Torque Converter Flex Lock-up Shudder

YEAR(S)	MODEL(S)	ADDITIONAL INFORMATION
2013 – 2015	RAV4

REVISION NOTICE

August 31, 2017 Rev1:

Figure 1. Magnet Installation Locations

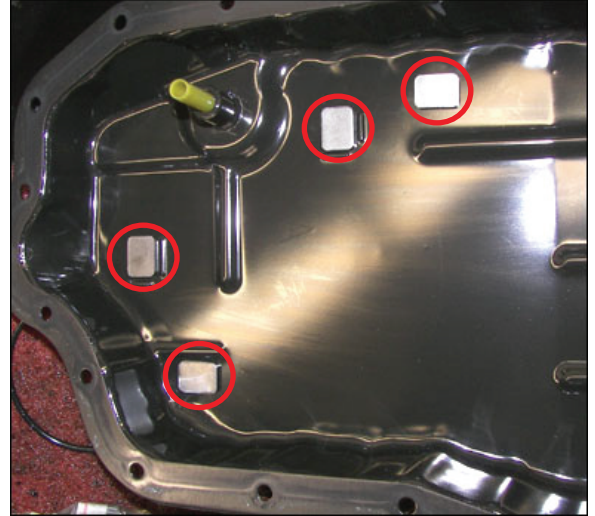
6. Install four NEW magnets as shown.

Figure 2. Location of Authorized Modifications Label for 2013 – 2015 RAV4

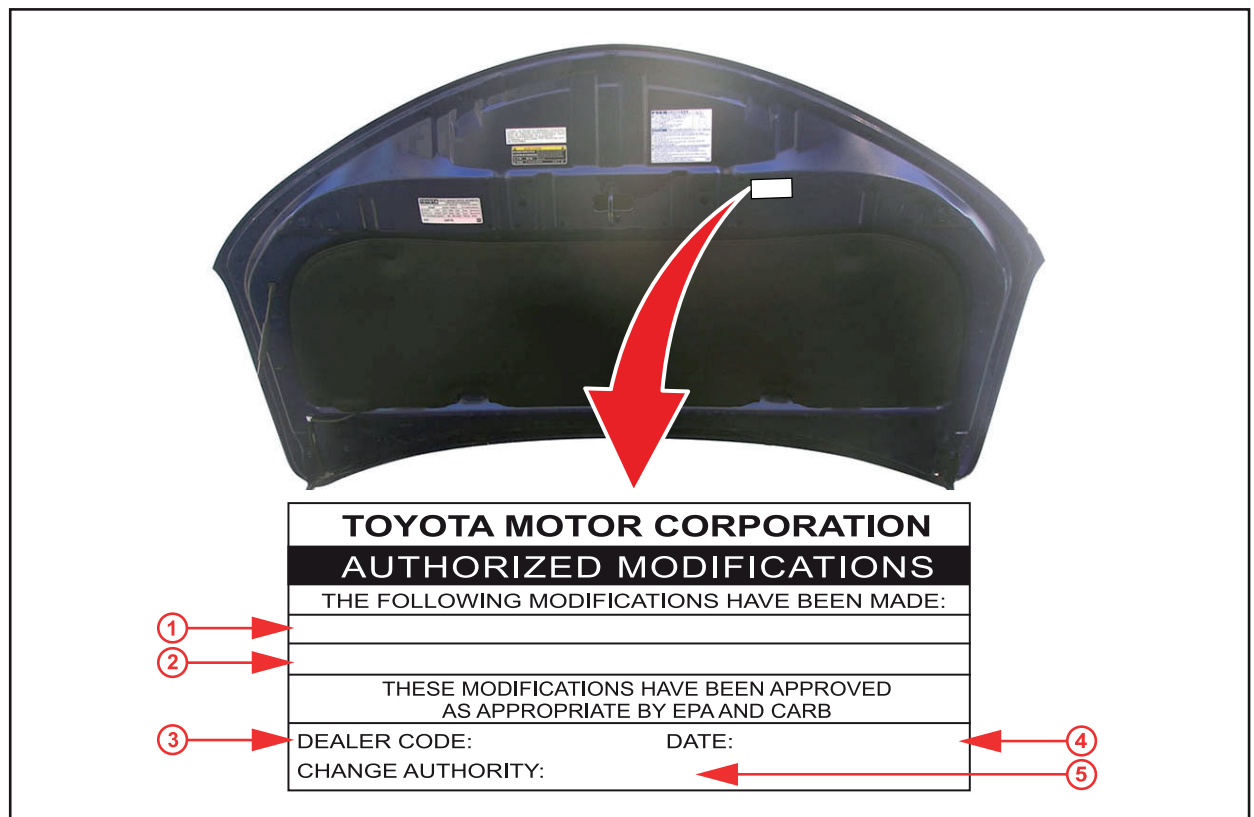
9. Check for the Authorized Modifications Label affixed to the vehicle in the location shown below. Confirm if the ECM (PCM) calibration has been updated.

Is the calibration ID listed the latest ECM (PCM) calibration?

11. Install the Authorized Modifications Label.
 - A. Using a permanent marker, enter the following information on the label:
 - ECM part number [Refer to the **Parts Information** section for the **NEW PART NUMBER**]
 - Calibration ID(s) [Refer to the **Calibration Information** section for the **NEW CALIBRATION ID**]
 - Dealer Code
 - Repair Date
 - Change Authority [**This bulletin number**]
 - B. Affix the Authorized Modifications Label to the vehicle at the location shown in Figure 2. The Authorized Modifications Label is available through the MDC, P/N 00451-00001-LBL.
12. Perform the Techstream ECT Reset Memory Utility and test drive the vehicle to confirm the repair.
